## **D. J.'S SUBDIVISION**

APPLICATION NUMBER Holdover DATE July 20, 2006

REQUEST Subdivision

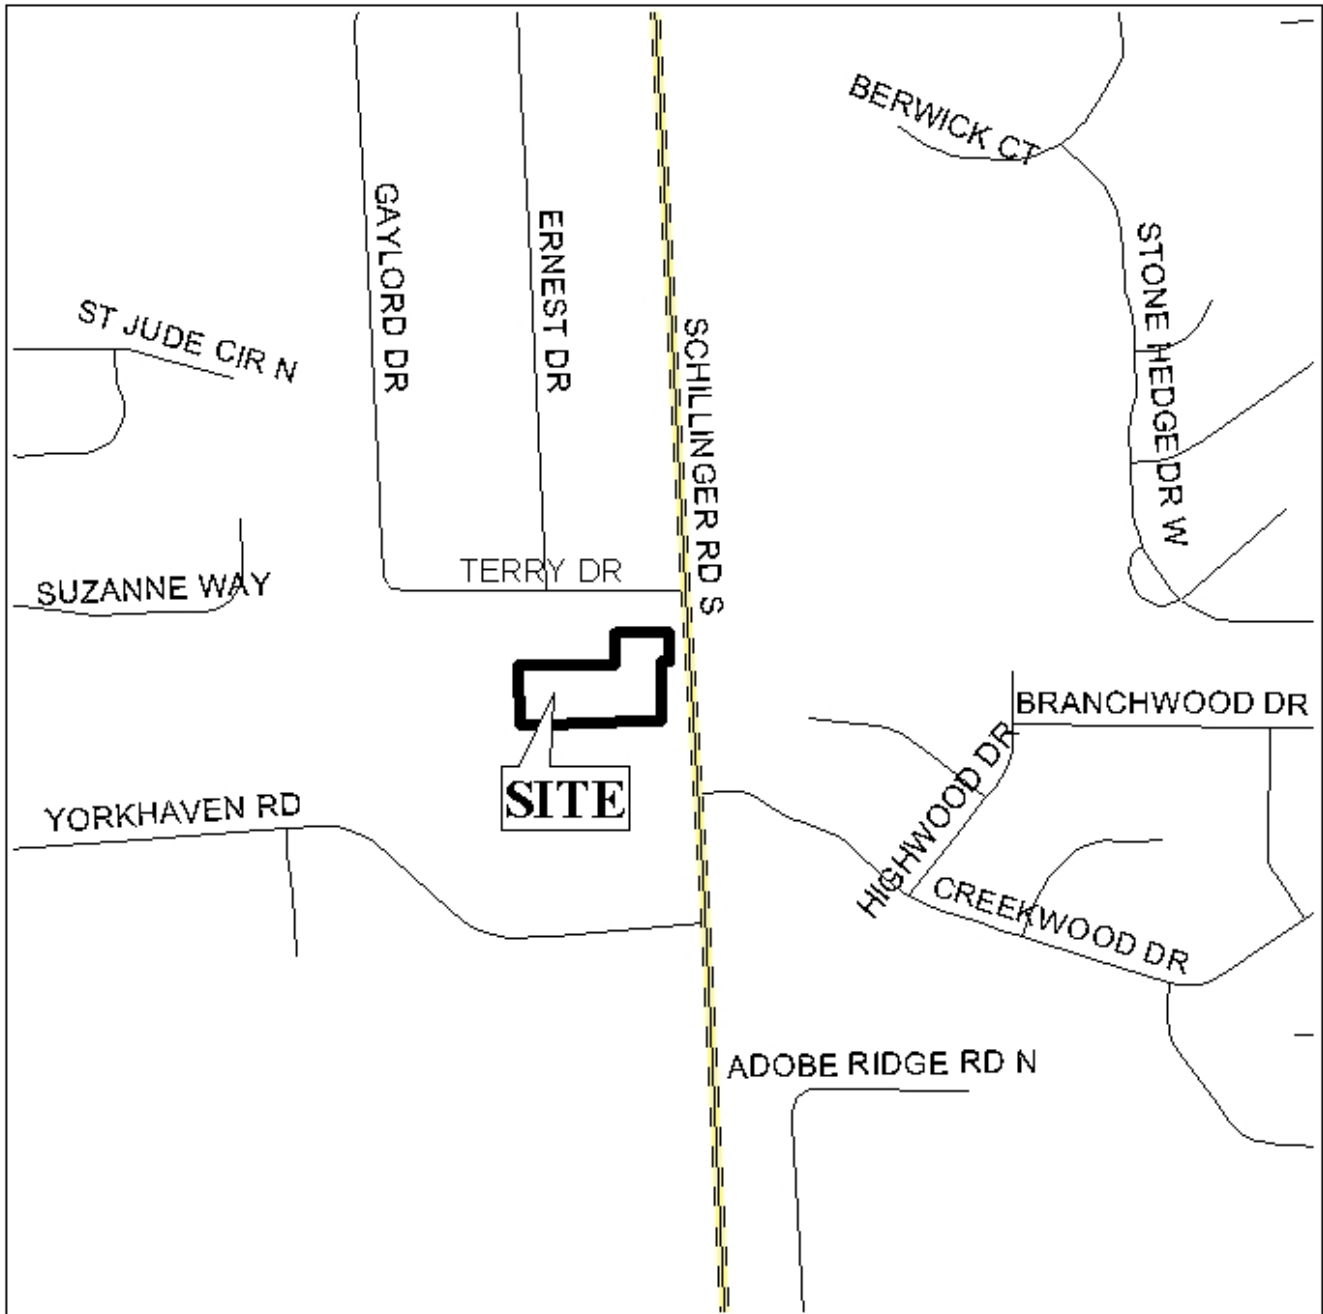
The purpose of the application is to create three lots of record from two existing lots. As shown, proposed Lot 1 would not change from its original configuration as a lot. The second original lot would be divided into a rectangular lot and a flag-shaped lot.

The site fronts Schillinger Road South, a planned major street with a 100-foot right-of-way along proposed Lot 1 and a 130-foot right-of-way along proposed Lots 2 and 3. As the Comprehensive Plan calls for a 100-foot right-of-way on Schillinger Road, no additional dedication would be required.

The surrounding area is characterized by very large-lot development, and the flag-shaped nature of proposed Lot 3 is uncharacteristic; thus it would not conform to Section V.D.1 of the Subdivision Regulations, which states: *"The size, width, depth, shape, and orientation of lots and the minimum building setbacks lines shall be appropriate to the location of the subdivision and the type of development and use contemplated."*

Furthermore, the site is located on a major street, which would pose access management concerns, especially for a driveway that may be less visible without a corresponding structure. If the subdivision were allowed, a shared driveway would be strongly recommended.

A possible alternative would be a horizontal division of the property. This would require a waiver of the maximum depth requirement (Section V.D.3). However, from the street, the configuration would more closely resemble other smaller residentially developed lots to the North and across Schillinger Road.

The 25-foot setbacks are not shown but would be required on the final plat.

*Based on the preceding, the plat is recommended for Tentative Approval, subject to the following conditions: 1) submission of proof that Lots 1 and 2 are served by public water and/or sanitary sewer, prior to signing the final plat; 2) the placement of the 25-foot building setback lines on the final plat; 3) the placement of a note on the final plat stating that any lots that are developed commercially and adjoin residentially developed property must provide a buffer, in compliance with Section V.A.7 of the Subdivision Regulations; and 4) the placement of a note on the final plat stating that the entire site is limited to three curb cuts, with size, location, and design subject to County Engineering approval.*
